City of El Paso – City Plan Commission Staff Report

Case No: SUSU11-00138 Desert Springs Unit Four
Application Type: Major Preliminary
CPC Hearing Date: January 26, 2012

DESERT SPRINGS UNIT FOUR

TYPICAL 50' ROW STREET SECTION DETAIL
(SEE SHEET 1 OF 3)

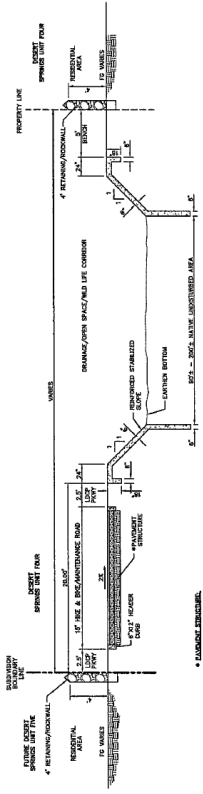
- To modify the right-of-way width from 52 feet to 50. The 50-foot right-of-way shall consist of 32 feet of pavement, two nine-foot parkways with five-foot sidewalks and six-inch standard curb and gutter.
- To allow for a 76-foot minor arterial right-of-way instead of a 64-ft collector arterial.
- To allow for a 120-foot modified right-of-way consisting of 64 feet of pavement with a 24' raised median, 5-foot sidewalk and 8-foot parkway on one side and an 8-foot meandering hike & bike trail with an 11-foot parkway on the other side.
- To allow for a turning heel radius between 70 and 110 degrees.
- A modification to Section 19.16.050.H. Preservation of Natural Arroyos allowing construction of improvements within an arroyo.
- To allow a street name to exceed the 13-character limit for Enchanted Springs Drive.

4. Transportation recommends the use of the current street cross sections which include five-foot sidewalks and five-foot parkways.

A modification to reduce right-of-way width from fifty-two (52') feet to a typical fifty (50') feet is also requested. The typical fifty (50') foot right-of-way shall consist of thirty-two (32') feet of pavement with sixteen (16') feet from center, two nine (9') foot parkways with five (5') foot sidewalks and six (6") inch standard curb and gutter.
